Re: Class 3 Permit Modification Technical Notice of Deficiency Letter Response
Shell USA, Inc. – Deer Park, Harris County
Hazardous Waste Permit No. 50099
Industrial Solid Waste Registration No. 30007
EPA Identification No. TXD067285973
Tracking No. 29917021; RN100211879/CN601542012

On behalf of Shell USA, Inc, this letter is to provide responses to the referenced Technical NOD in your letter dated November 14, 2024. Specific to each NOD, our responses are as follows:

**Subject: Shell SET Front Ends Project – West Basin & Offsite Areas
Preliminary Settlement Estimate**

CALCULATION SHEET

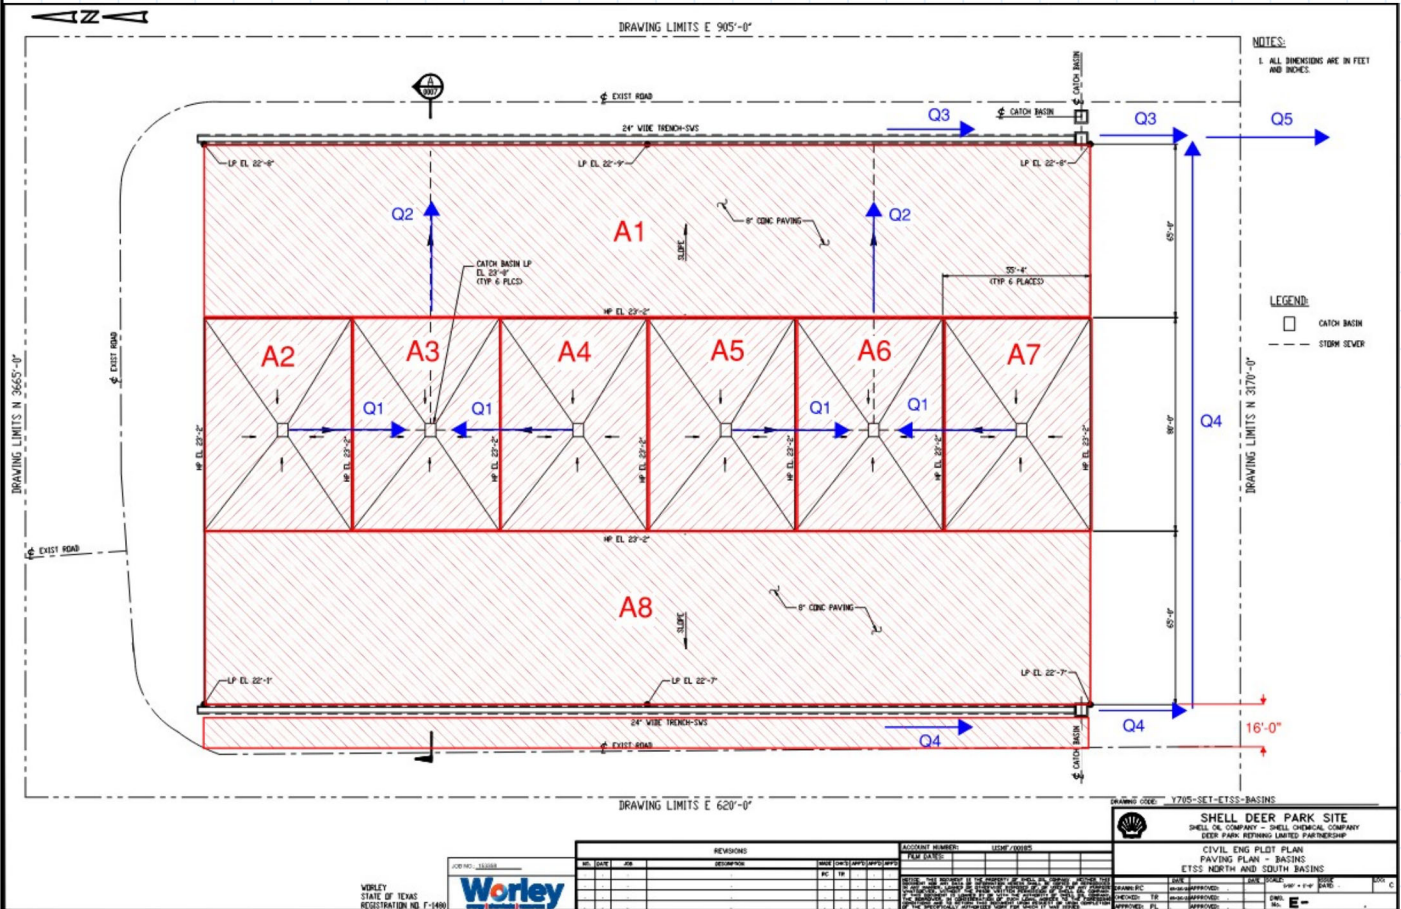
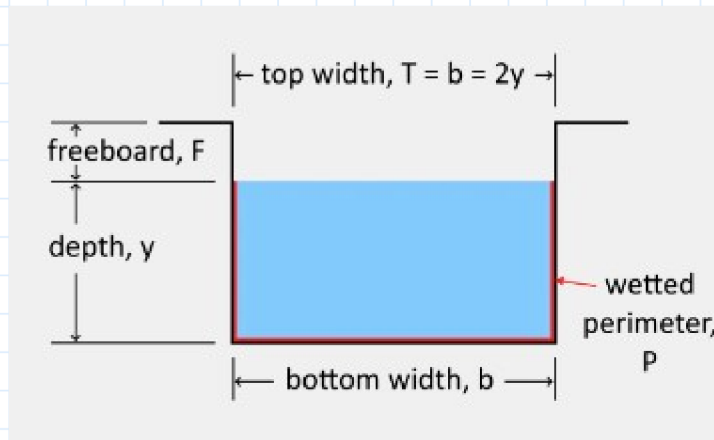
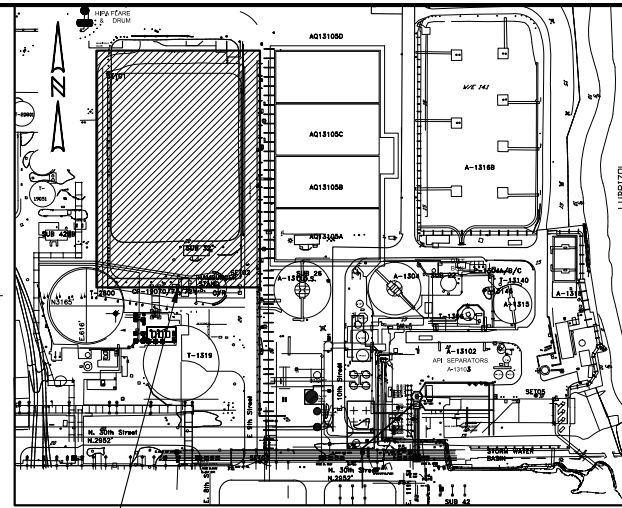
T4.2 Provide information showing how the stormwater from at least a 25-year, 24-hour rainfall event is collected and removed from the closed West SET Basin.

Response: The proposed stormwater drainage plan with calculations is attached and will be incorporated into the revised Section V, 2025 cap modification plan and Section VII (as appropriate).

SDPMCP-00185-CS-DSK-0001-B

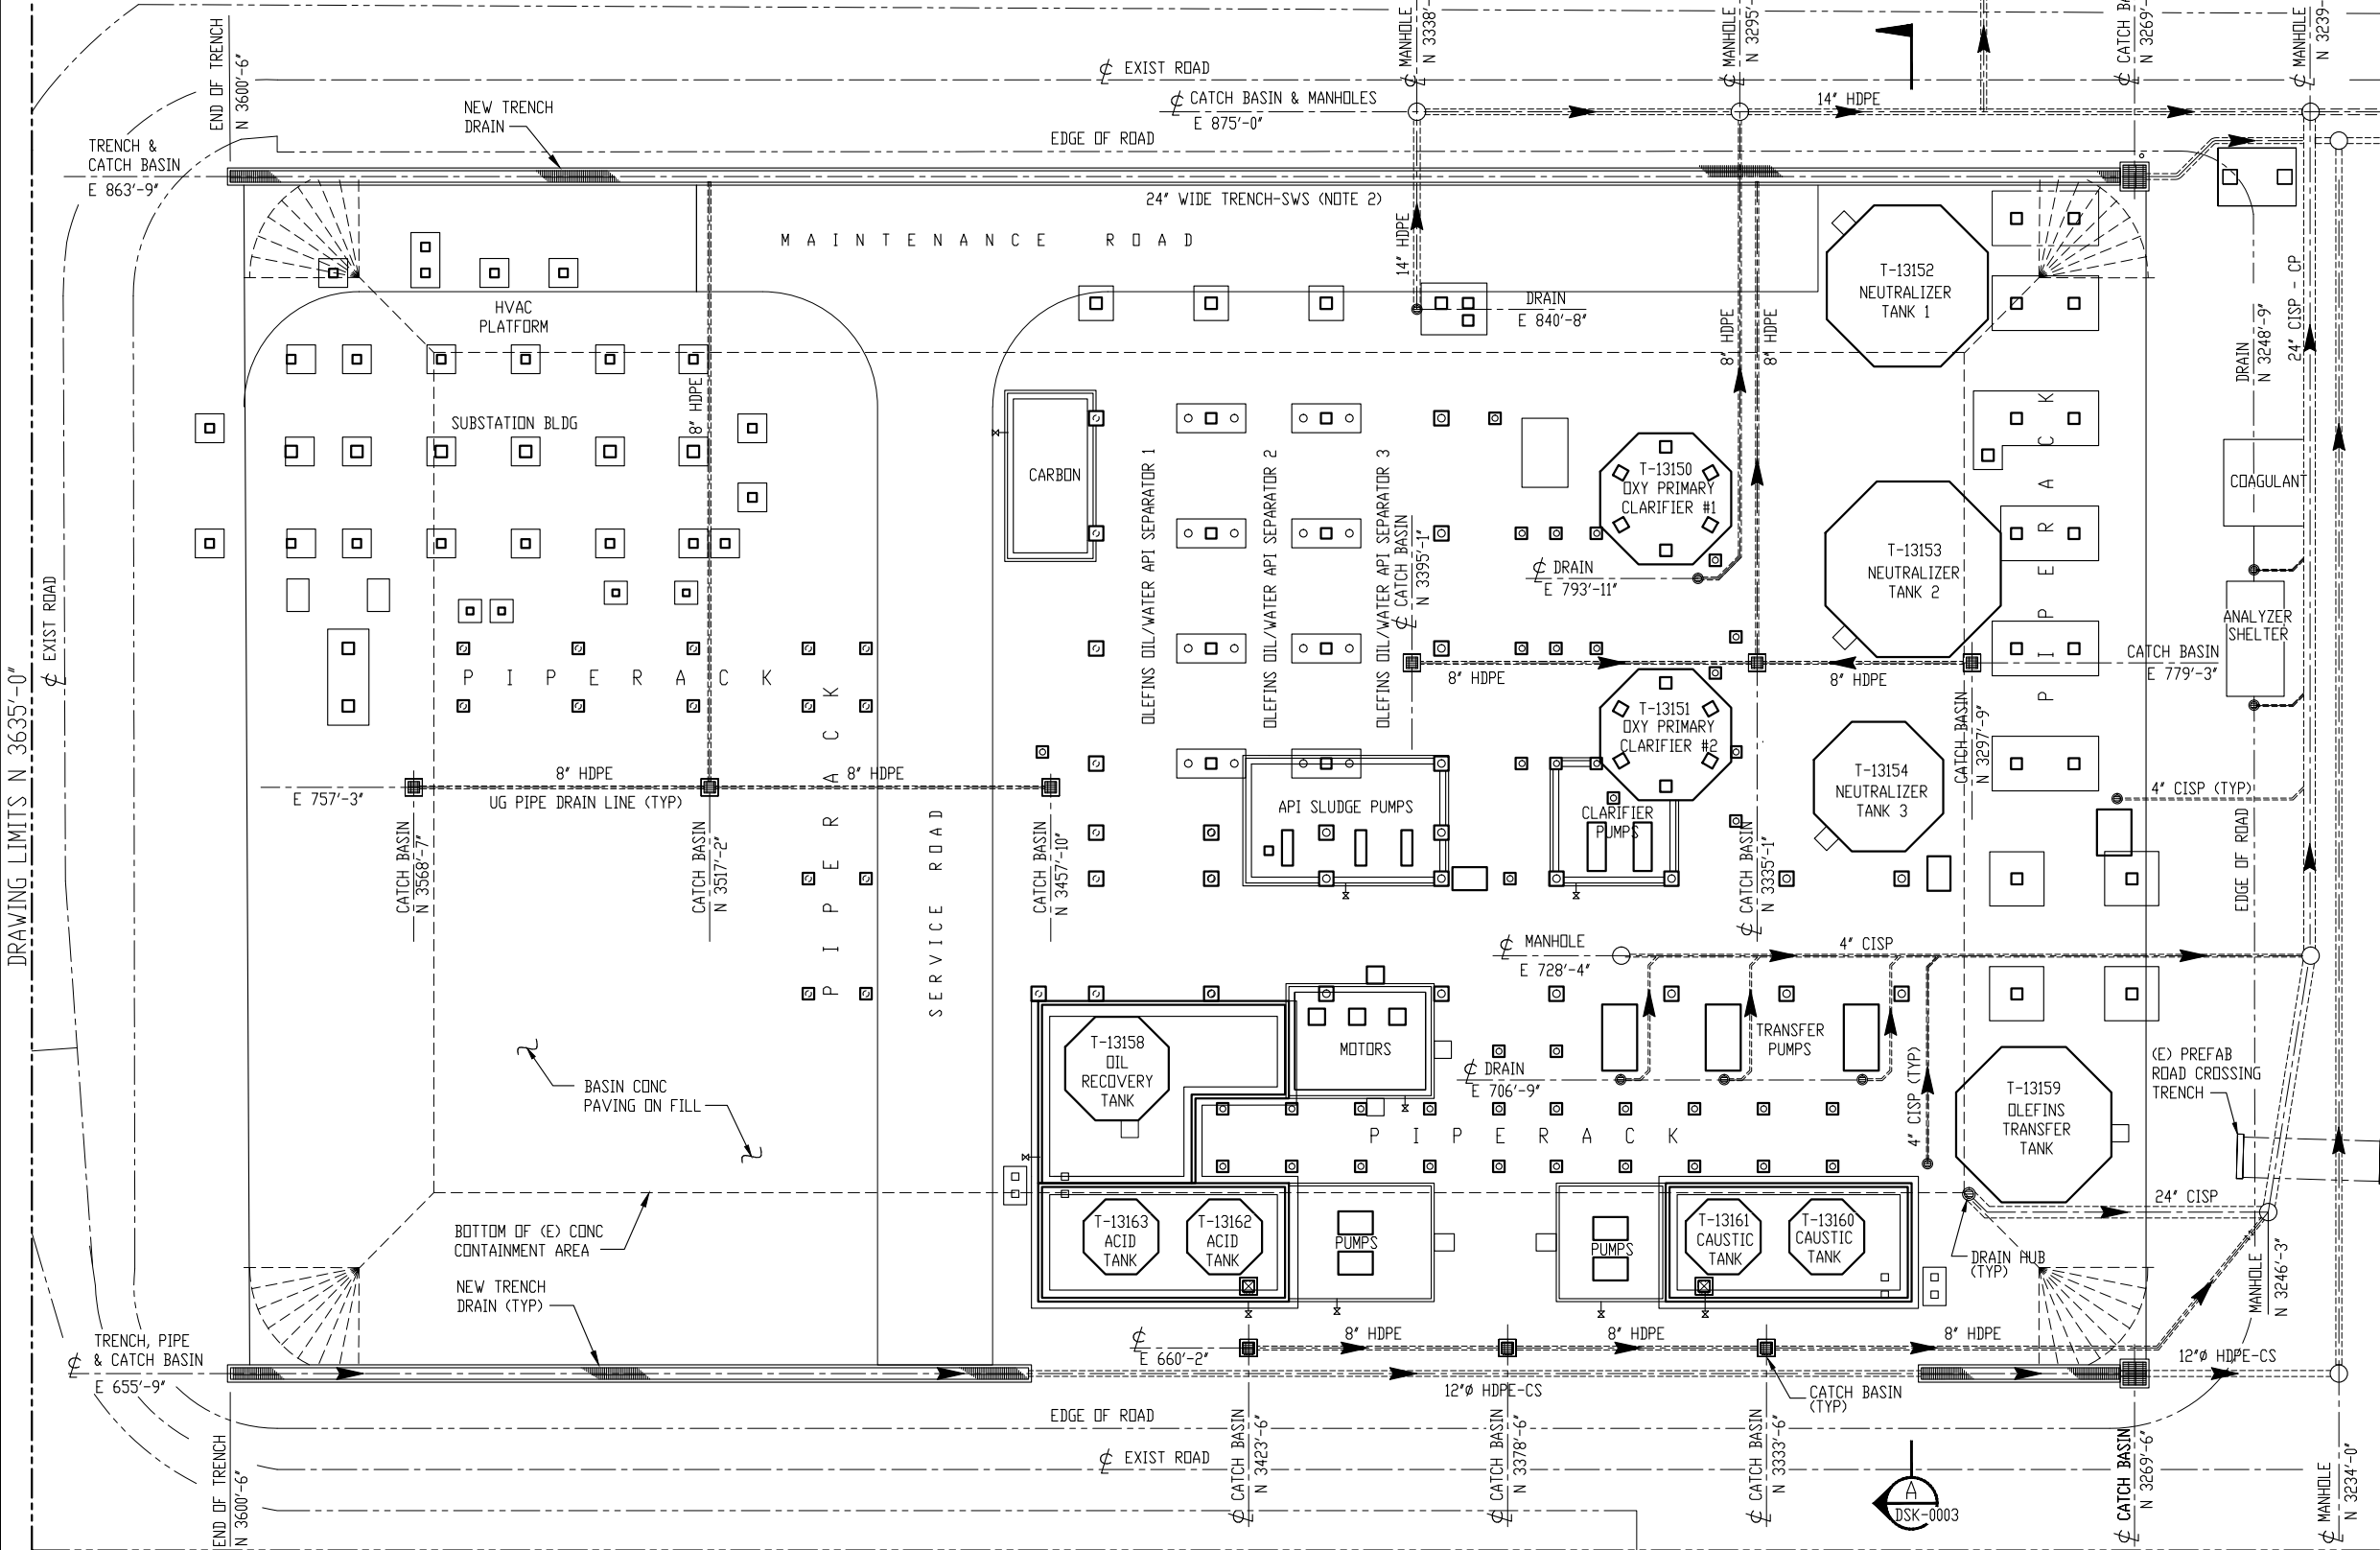
T4.3 Each engineering drawing and calculation sheet must be sealed, signed, and dated separately by a Texas licensed Professional Engineer (P.E.) and must also contain the engineering firm registration number (if applicable), as required by the Texas P.E. Board.

Response: The revised drawings are attached and will be incorporated into the revised Section V, 2025 cap modification plan (under revision) and Section VII revised closure plan (under construction).

SDPMCP-00185-CS-DSK-0003-B

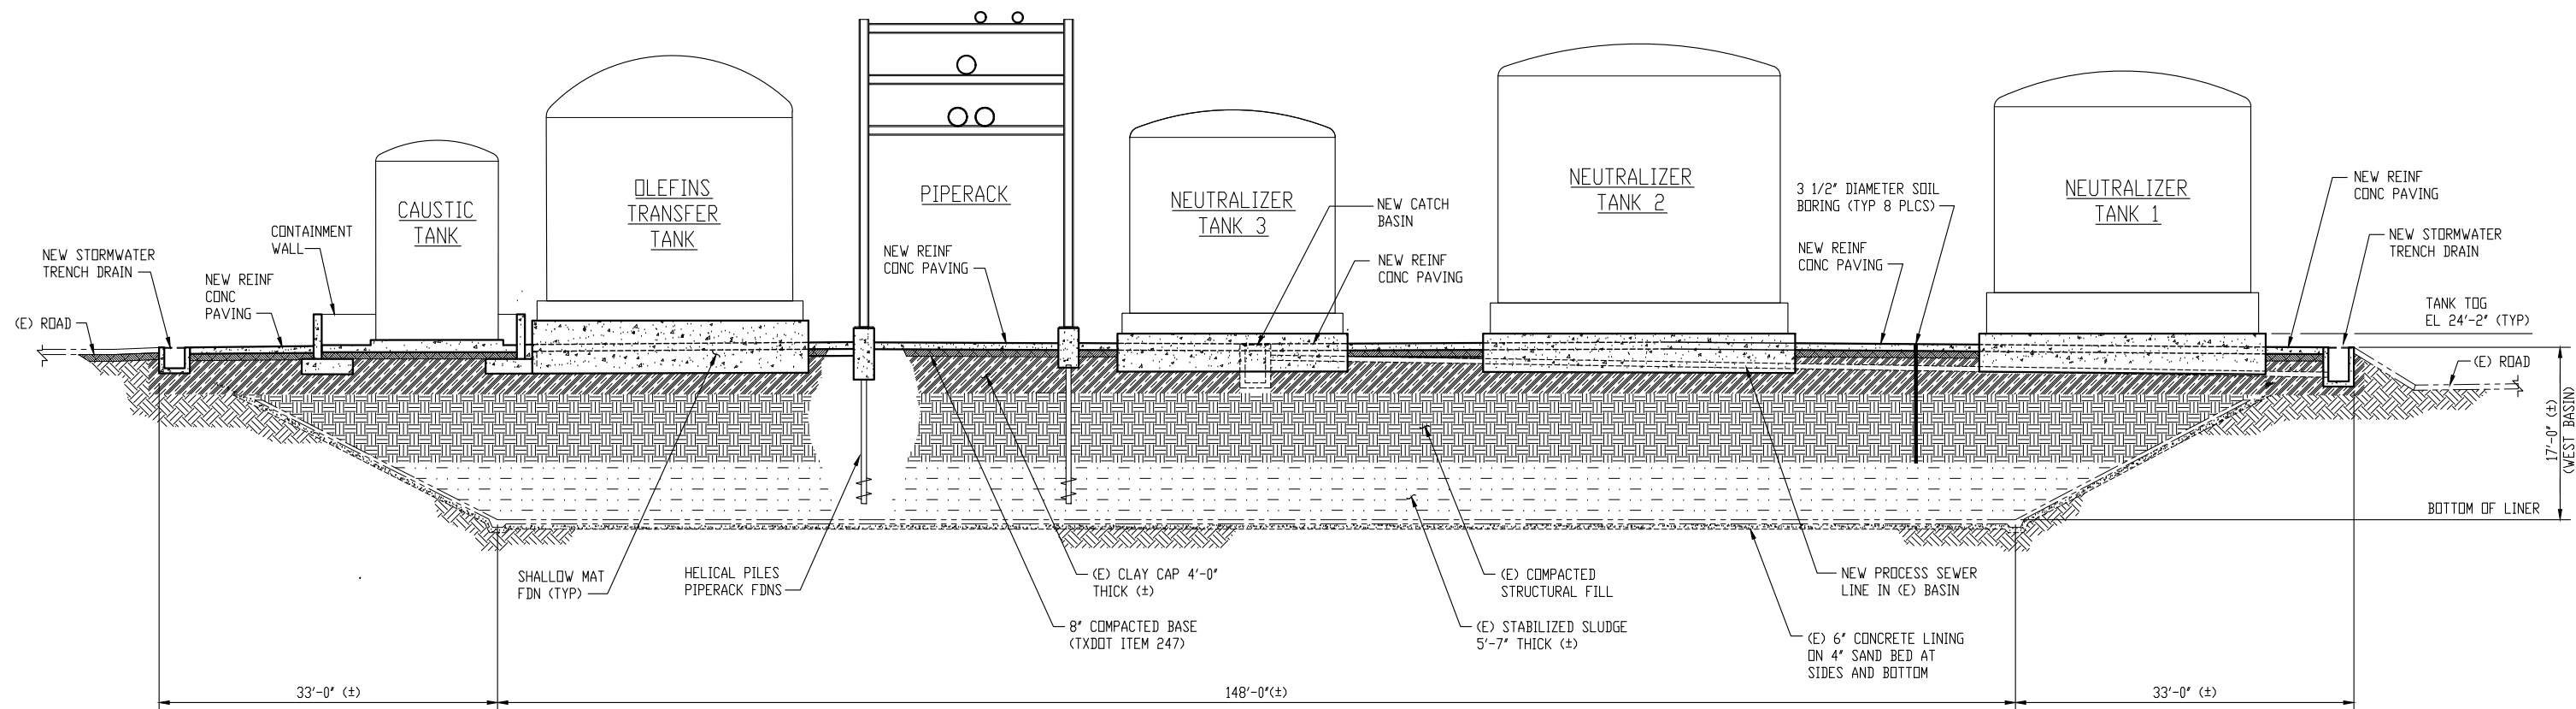
T4.1 Provide a stability analysis showing the final cover system for the West SET Basin, as modified, will accommodate settling and subsidence due to the overburden loads so that the cover's integrity is maintained.

Response: The stability analysis is attached and will be incorporated into the revised Section V, 2025 cap modification plan (under revision) and Section VII revised closure plan (under construction).

SDPMCP-00185-CS-DSK-0004-B

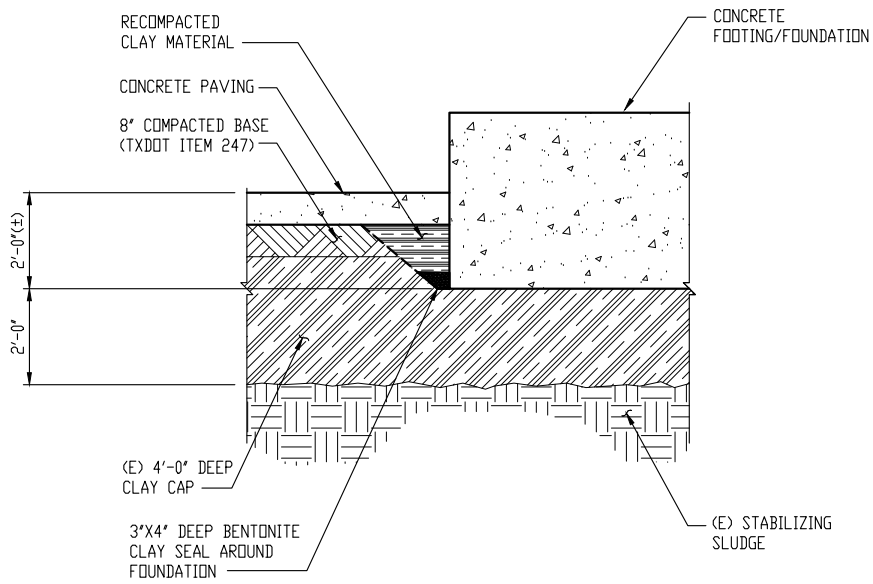
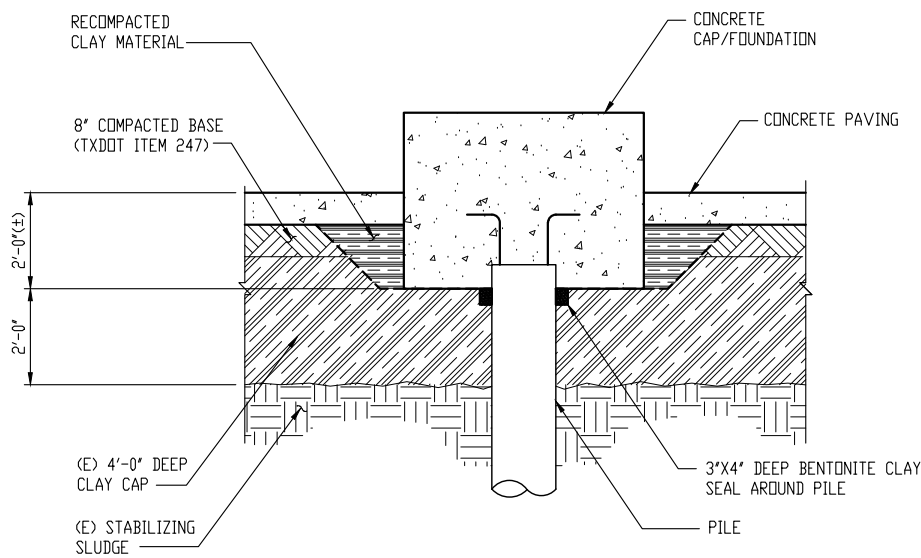
T5.3. Revise the closure plan for the West SET Basin to describe procedures for plugging and/or sealing the holes for installation of the piling system.

- Where foundations are required to support equipment, up to 2 feet of the clay seal will be removed and be replaced with a concrete foundation.
- A bentonite clay seal shall be installed around the perimeter of the foundation to seal the foundation and prevent migration of liquids through the clay seal (see drawing SDPMCP-00185-CS-DSK-0004)

- All installed helical piles shall be encased in a concrete cap (pedestal).
- A bentonite clay seal shall be installed around the perimeter of the top of the pile to seal around the pile preventing migration of liquids through the clay seal (see drawing SDPMCP-00185-CS-DSK-0004).
